Notice of Allowability	Application No.	Applicant(s)
	10/710,788	STOLL ET AL.
	Examiner	Art Unit
	Dana Ross	3722
The MAILING DATE of this communication appears on the cover sheet with the correspondence address All claims being allowable, PROSECUTION ON THE MERITS IS (OR REMAINS) CLOSED in this application. If not included herewith (or previously mailed), a Notice of Allowance (PTOL-85) or other appropriate communication will be mailed in due course. THIS NOTICE OF ALLOWABILITY IS NOT A GRANT OF PATENT RIGHTS. This application is subject to withdrawal from issue at the initiative of the Office or upon petition by the applicant. See 37 CFR 1.313 and MPEP 1308.

ALLOWANCE

Application Serial No. 10/710,788
Reply to Office Action of December 1, 2005
Replacement Sheet

Fig-5

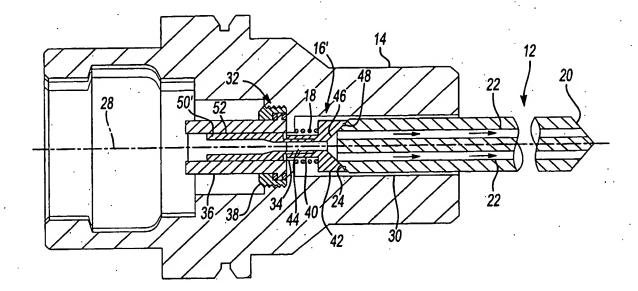
1. The drawing for Figure 5 showing a disclosed embodiment of Applicant's invention was received on 17 February 2006. This drawing are acceptable.
